**9-21-2012**  
**Response to PADEP Comments**

### **Resolution of Technical Issues Related to the Urban Retrofit and Performance Standards Expert Panel Recommendations**

## **June 6 2012 Summary of Watershed Technical Work Group Comments on Memos**

Figure 2. Revised TN Adjustor Curve

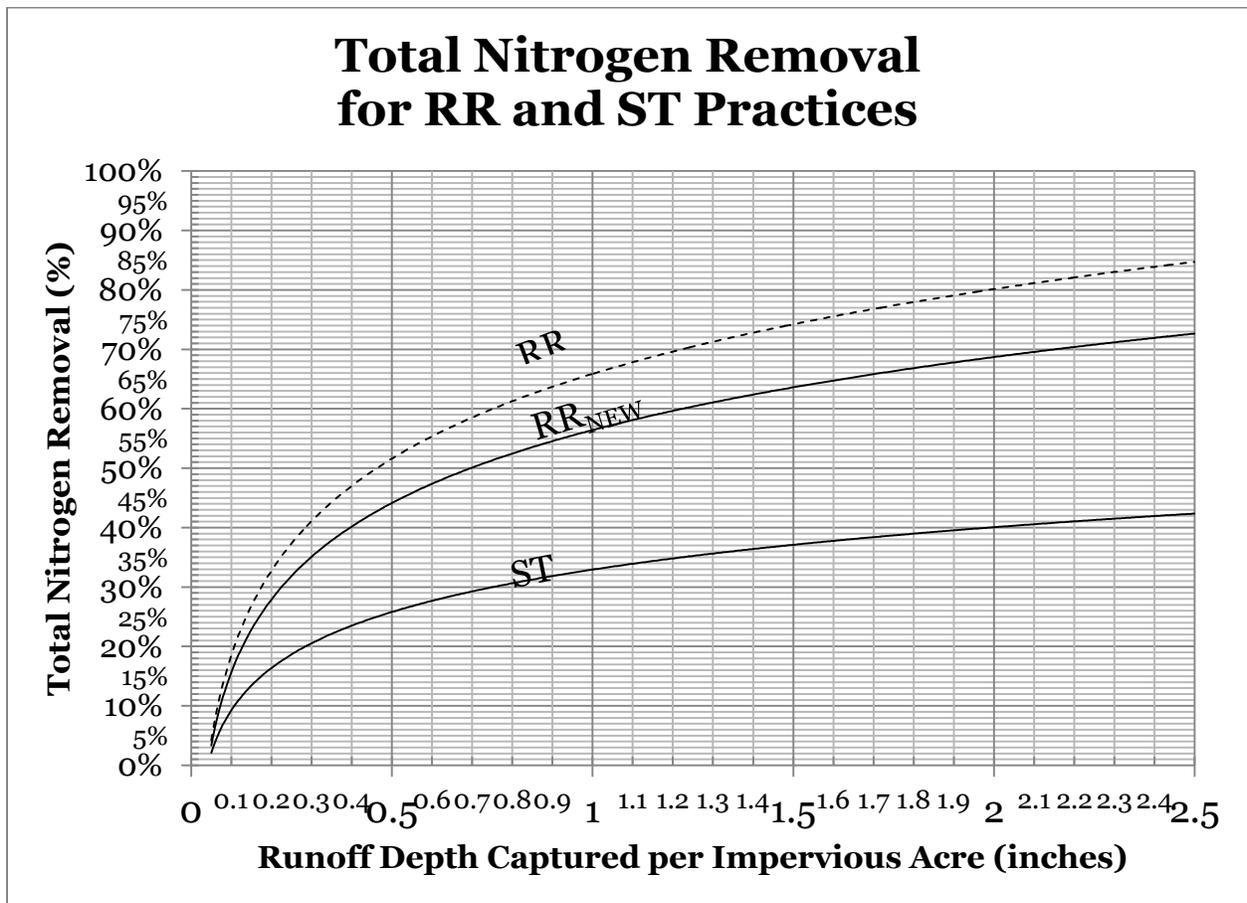
The discount factor is then applied to the anchor rates used to derive a new N adjustor curve. The anchor rate for RR practices would be adjusted downward from the current 70% to 57%, and the existing runoff frequency spectrum equation would be used to develop a new, lower curve for TN removal. An example of the how this discount influences the existing N adjustor curve is shown in Figure 2.

**Option 1 Action:** The USWG supports the modified resolution as provided above, and that the revised N removal rate adjustor curve shown above replace the current one. Design examples would be modified accordingly, and the preceding technical discussion be added to the appropriate appendix that describes how the adjustor curves were derived.

Figure 3: Proposed reduction Multiplier for TN removal Rate based on % pervious area into the drainage area to a retrofit or a new stormwater BMP

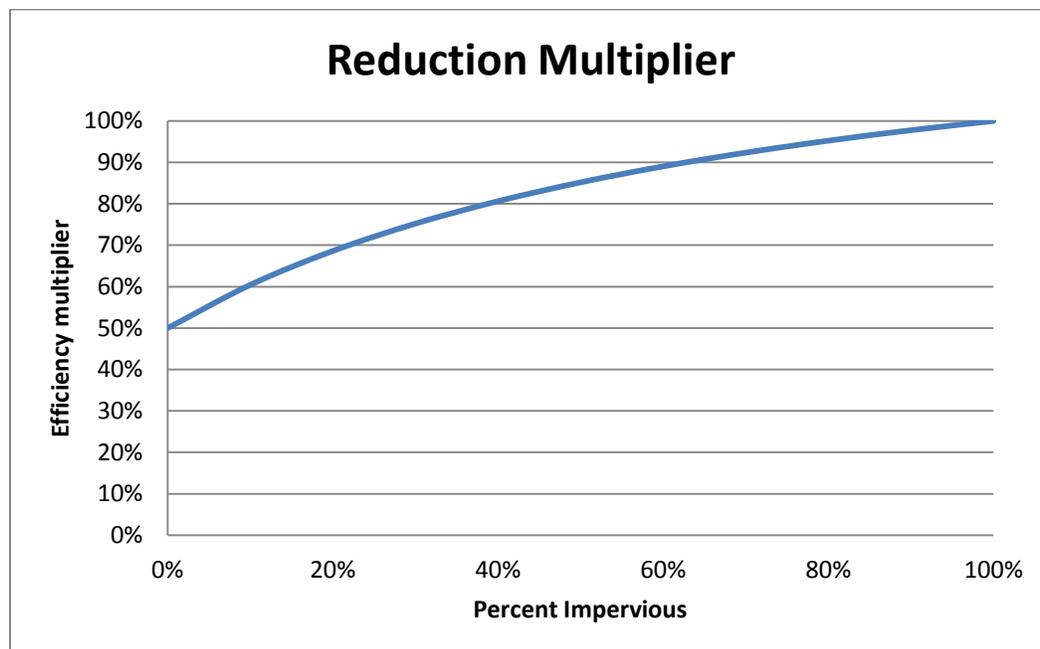
As shown in Figure 3, the multiplier would be 1.0 for a practice with a 100% impervious drainage area, and 0.5 for a facility that is 100% pervious. This multiplier is then used to adjust the removal rate determined from the new TN adjustor curve.

Figure 4: Baltimore County Stream Monitoring Data for Base flow Nitrate and Total Annual Nitrogen Loads (Stewart et al, 2005)

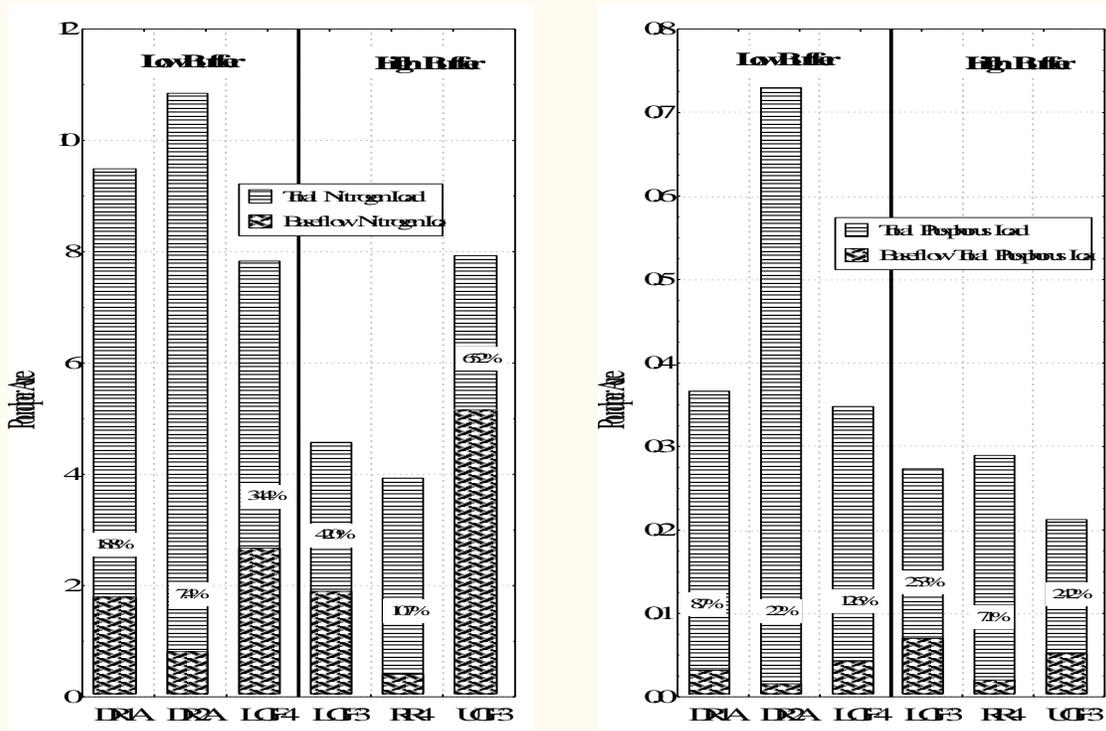
Some scientific corroboration of the Shenk modeling approach can be found in an analysis of urban stream nitrate loads taken from Baltimore county, which compare the ratio of base flow nitrate loads to total annual loads (See Figure 4, from Stewart et al, 2005)

If it conservatively assumed that all of the base flow nitrate monitored in urban streams represents untreated base flow, and the ratio of the annual base flow nitrate load to total annual stream total nitrogen load represents the discount factor. These watersheds are in the 25 to 50% IC range, so the average ratio of base flow nitrate to total nitrogen load of around 20 to 30% is reasonably consistent with the Shenk multiplier equation (the one stream value of 54% is an outlier, and appears to reflect the impact of dry weather sewage discharges via illicit discharges and/or sanitary sewer overflows).

Figure 2. Revised TN Adjustor Curve

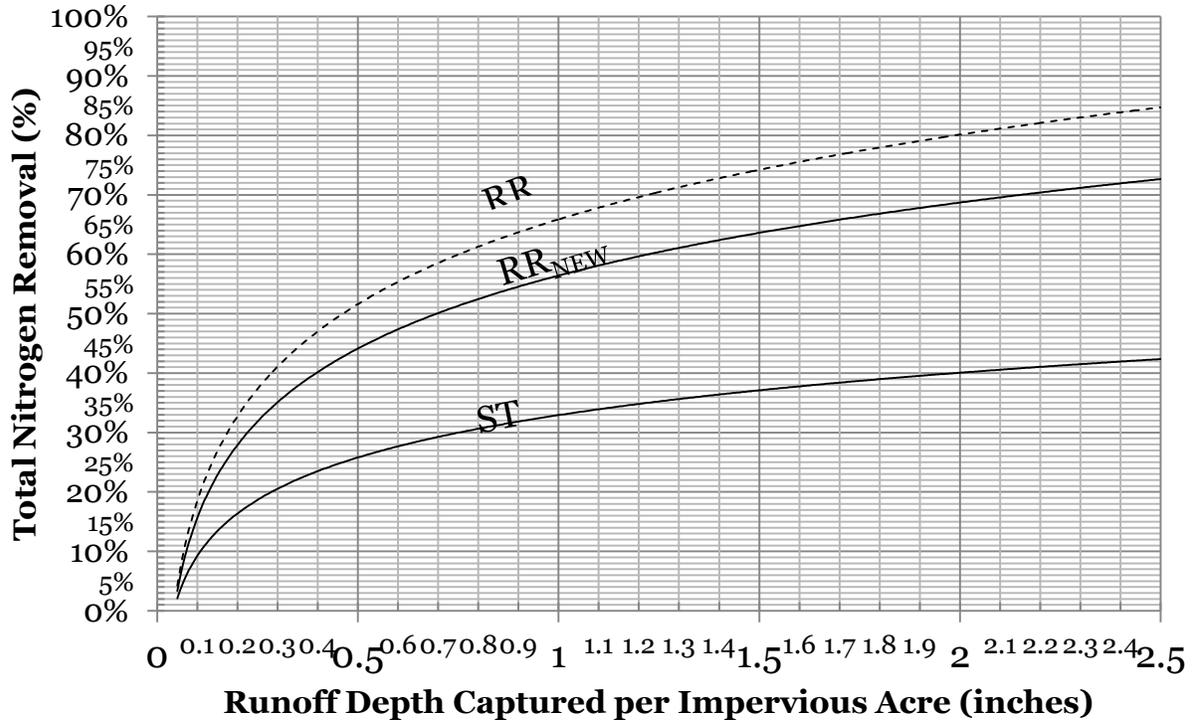
The discount factor is then applied to the anchor rates used to derive a new N adjustor curve. The anchor rate for RR practices would be adjusted downward from the current 70% to 57%, and the existing runoff frequency spectrum equation would be used to develop a new, lower curve for TN removal. An example of the how this discount influences the existing N adjustor curve is shown in Figure 2.

Figure 3: Proposed reduction Multiplier for TN removal Rate based on % pervious area into the drainage area to a retrofit or a new stormwater BMP

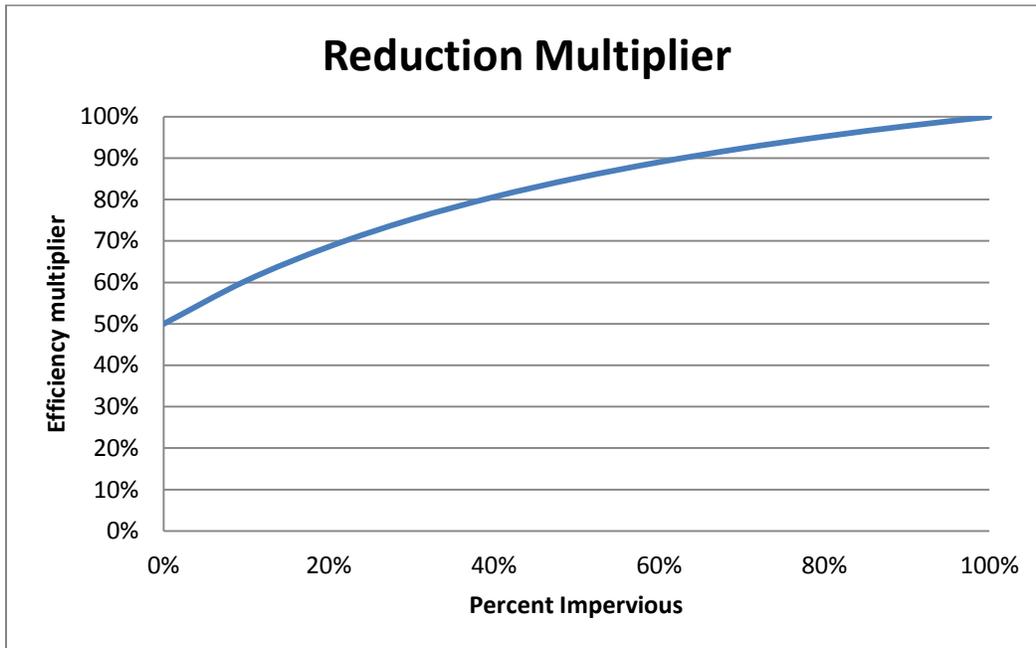
As shown in Figure 3, the multiplier would be 1.0 for a practice with a 100% impervious drainage area, and 0.5 for a facility that is 100% pervious. This multiplier is then used to adjust the removal rate determined from the new TN adjustor curve.

Figure 4: Baltimore County Stream Monitoring Data for Baseflow Nitrate and Total Annual Nitrogen Loads

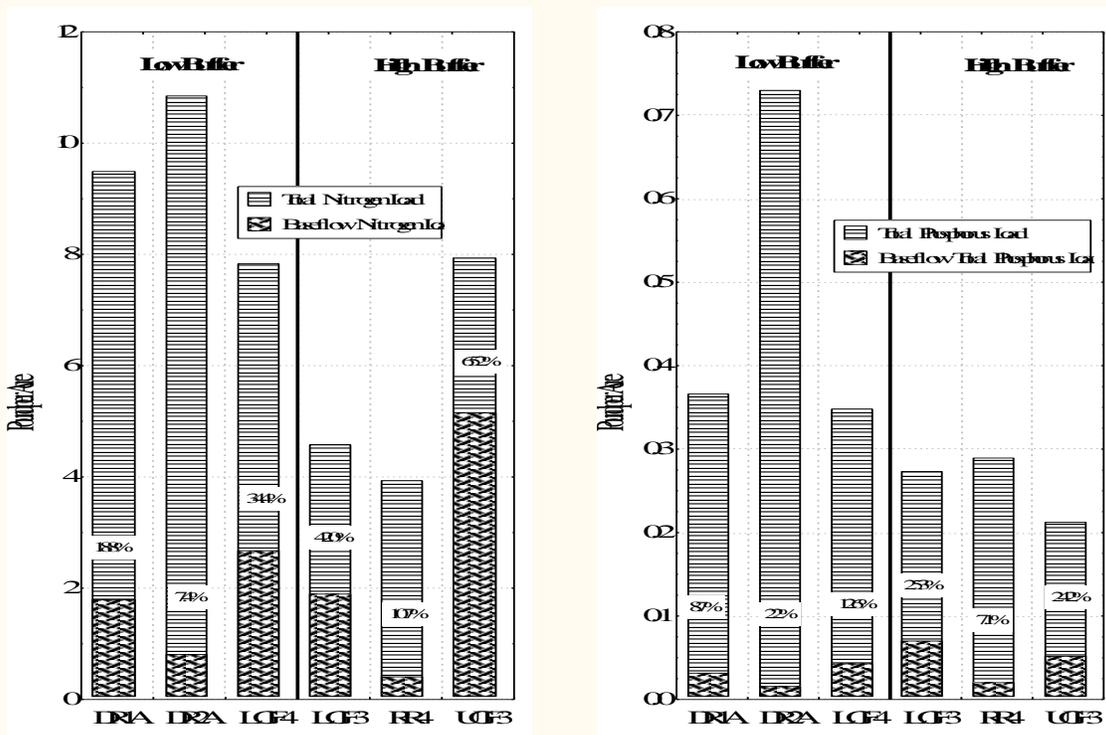
Some scientific corroboration of the Shenk modeling approach can be found in an analysis of urban stream nitrate loads taken from Baltimore county, which compare the ratio of baseflow nitrate loads to total annual loads (See Figure 4, will get the source, but I think it is Baltimore LTER)

If it conservatively assumed that all of the base flow nitrate monitored in urban streams represents untreated base flow, and the ratio of the annual base flow nitrate load to total annual stream total nitrogen load represents the discount factor. These watersheds are in the 25 to 50% IC range, so the average ratio of baseflow nitrate to total nitrogen load of around 20 to 30% is reasonably consistent with the Shenk multiplier equation (the one stream value of 54% is an outlier, and appears to reflect the impact of dry weather sewage discharges via illicit discharges and/or sanitary sewer overflows).
